## ITEM DISCUSSION

Queen Anne Elementary  
SDAT 09 01 May 2017

## Deliveries and Service

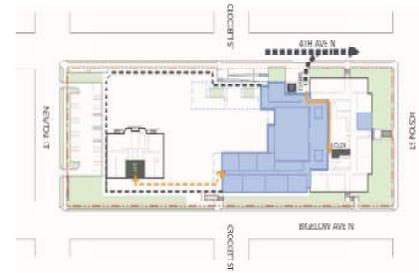
- 9.4 Corrie Rosen presented feedback from meetings with various local agencies and stakeholders.
- a. - SPS Facilities:
    - 1. - A dedicated delivery area primarily for daily food delivery is needed near the kitchen in the brick building

- 2. - A dedicated area for dumpsters is also needed near the main waste generator (the kitchen), or dumpsters may end up being placed in undesirable locations in the center of the site

- a. - The biggest circulation change since the last SDAT was the incorporation of a loading dock and receiving area off of 4<sup>th</sup> Ave N. JoAnn indicated that site constraints required the loading to be located on 4<sup>th</sup> Ave, close to the new main entrance, but that screening will be used to mitigate the presence of the loading area on 4<sup>th</sup> Ave.
